STAFF REPORT

SUBJECT:	PRS 21-0619 RU/S	PLANNING AREA:	Ruskin
REQUEST:	Minor Modification to a Planned Development	SECTOR	South
APPLICANT:	Eisenhower Property Group, LLC		
Existing Zoning : PD 19-0104		Comp Plan Category: R-4

PRS 21-0619

Figure 2 –Proposed PD Plan

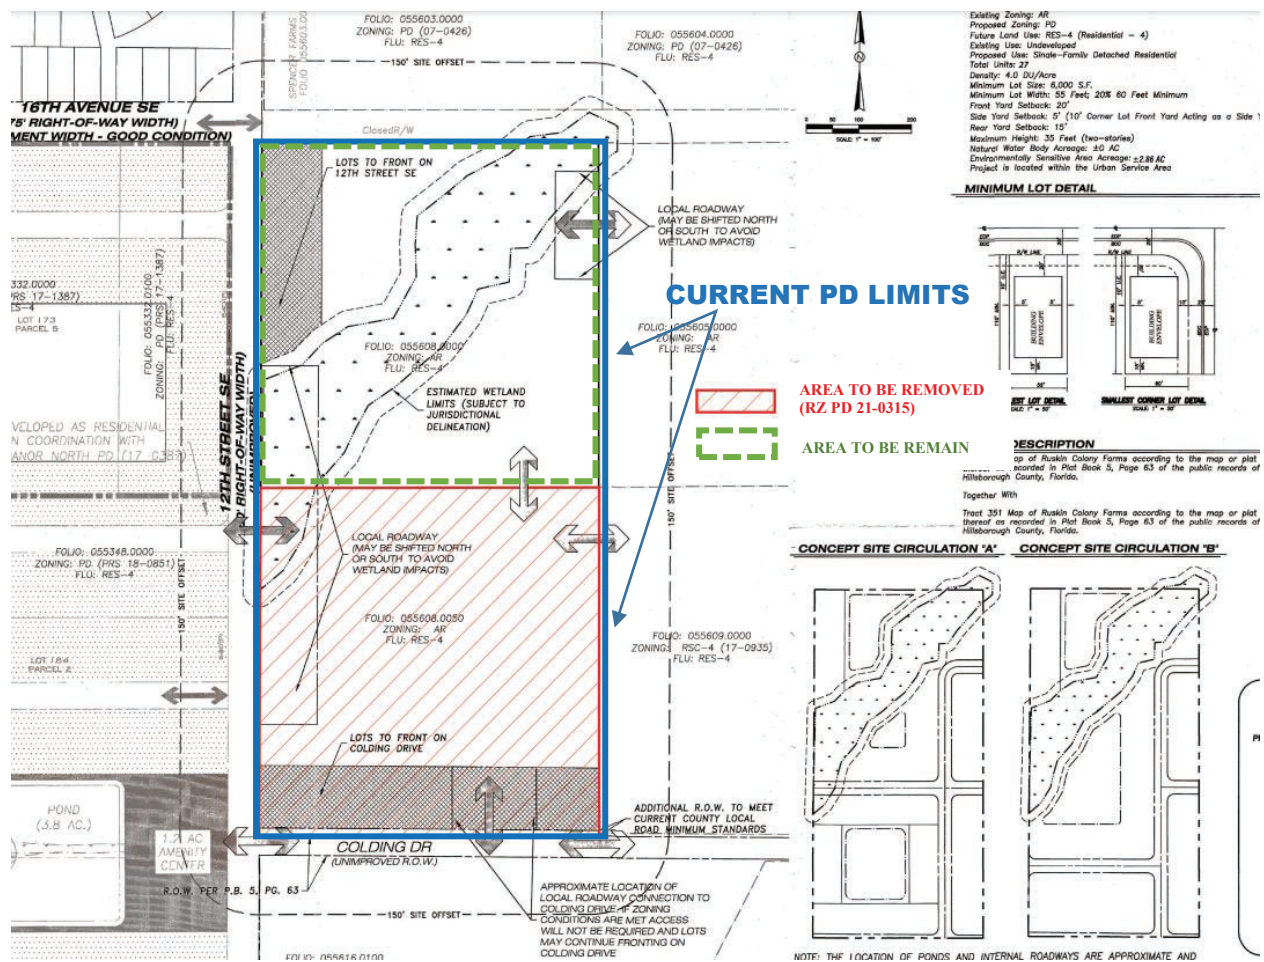
Additionally, all access points will remain in place. A cross access arrow is being placed along the south to correspond with the concept site circulation diagrams noted in the original PD Plan from 2019. This access point is also consistent with the new PD application (21-0315) access location.

Lots along the PD line to south would be permitted to be placed across the PD line (shared with PD 21-0315) if developed as part of a unified development. This would allow the subject PD to be developed consistently with the concept site circulation plans as approved today.

The project will remain ungated and also retain access connections to the east and south. Due to the existence of wetlands, connection to the north road (16th Ave SE) is limited. As shown on the PD Plan, a number of lots would face the public roads to the west (12th St SE) to take advantage of the existing local public road network as approved today. All other access points would be provided from adjacent sites to the east and south.

Figure 3 – Concept Plans A and B

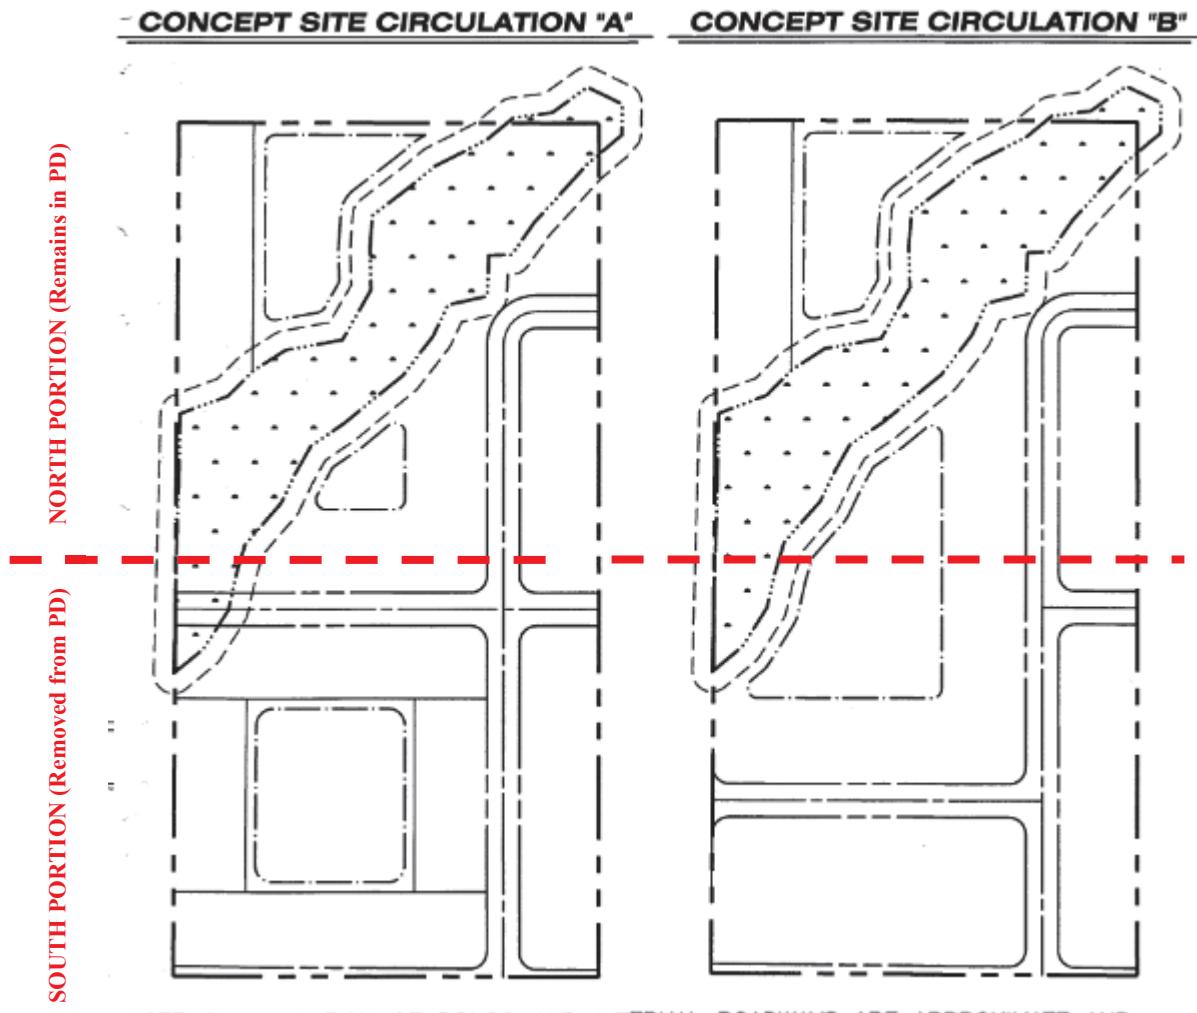
The remaining PD site could still be developed consistent with Concept Site Circulation Plan A indicated on the approved PD General Site Plan. Additionally, the site would have the ability to place lots across the PD line to south as part of a unified development plan, which would make the project developed consistent with the concept circulation plans as approved today. The maximum number of units allowed per the FLU designation and available upland acreage would be 27. The companion PD application (21-0315) shows access points connecting to PD 19-0104 that correspond with the Concept Site Circulation Plan A. Therefore, based on these considerations, staff finds the minor modification supportable, with conditions.

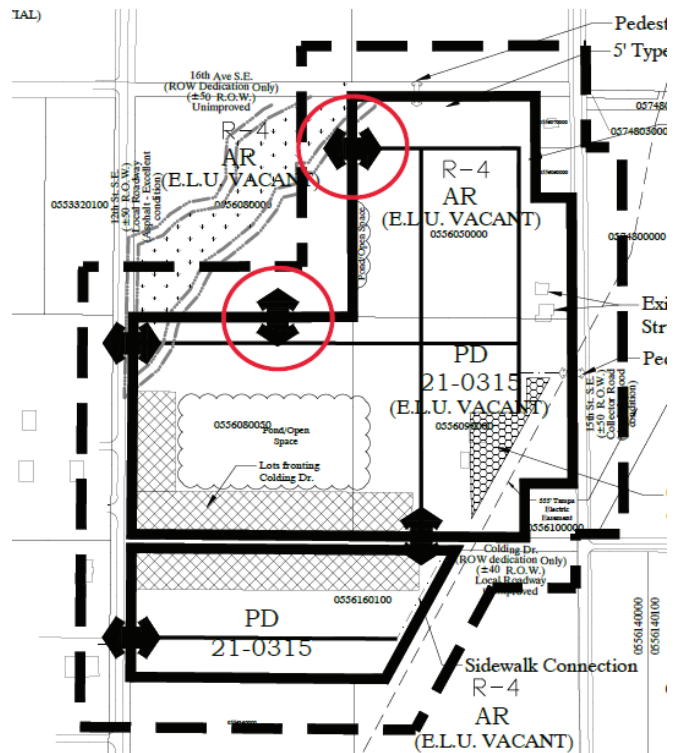
Two connections to the portion of the proposed adjacent PD 21-0315 will remain along the southern and eastern portions of the projects. Dwelling units north of the wetland will take direct access via 12th

St. SE. These connections are shown in red in the image at right. With respect to the northernmost of these two connections, staff engaged with the applicant of PD 21-0315 regarding the location and design of this connection, to ensure that it could be effectuated without requiring the adjacent property owner to impact the wetland or 30-foot wide wetland setback. Staff has included zoning conditions to this effect within the adjacent proposed PD.
